08/08/11 CO #135

CHANGE ORDER 135  
INSTRUCTION BULLETIN  
DEFERRED APPROVAL  
ADDENDUM

CHILDREN'S HOSPITAL  
OF ORANGE COUNTY

A3.3P

## A6 AREA "P"

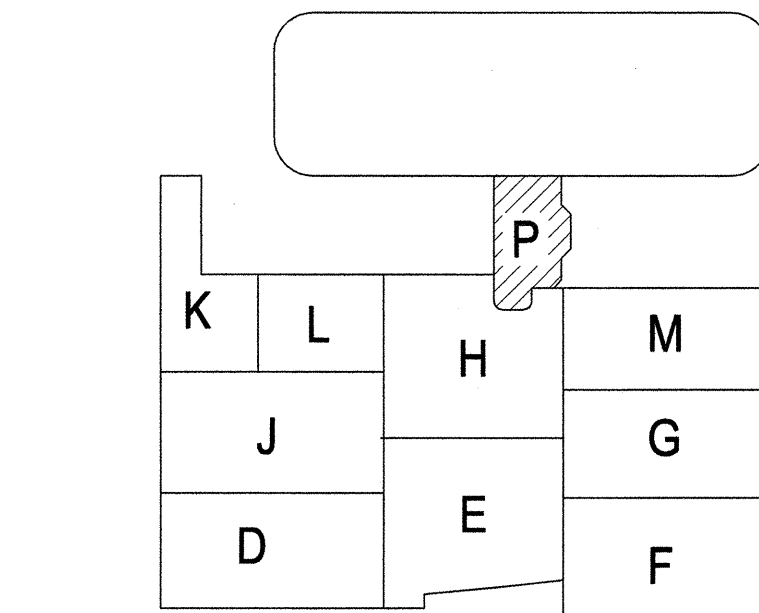
1. EXPANSION JOINT.
2. INTEGRATED DOUBLE EGRESS DOOR, WALL RECESSED. SEE D5 & D6/A11.4 FOR SIMILAR.
3. REMOVE AND REINSTALL LOCKERS AS REQUIRED TO INSTALL NEW 2-HOUR FIRE/SMOKE PARTITION AND FURRING PARTITION.
4. SEE INCREMENT 6 FOR CONSTRUCTION NOTES THIS AREA.
